TECHNICAL BULLETIN

407-23-140

MODEL AFFECTED: 407

SUBJECT: COLLECTIVE PITCH TRANSDUCER 412-074-101-105, INTRODUCTION OF.

Figure 1 – Design Improvements to 412-074-101-105 Transducer

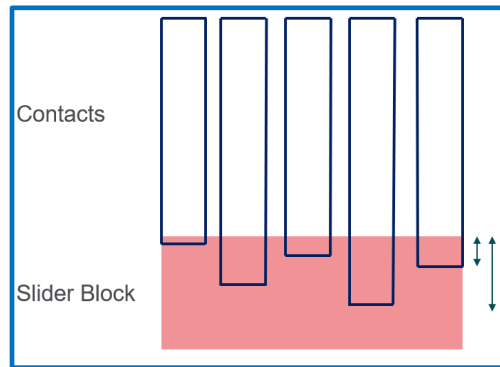
Contact staking process: Contacts installed into preset angled piece for more repeatable/consistent installation.

Installed vs. Uninstalled Requirements: After contacts are installed, pressure on housing is measured and must respect specific tolerance to insure consistency.

Brush Design: Brush lengths are different to help deal with different resonant frequencies. Material of brush changed and is less brittle when subjected to cold temperatures.
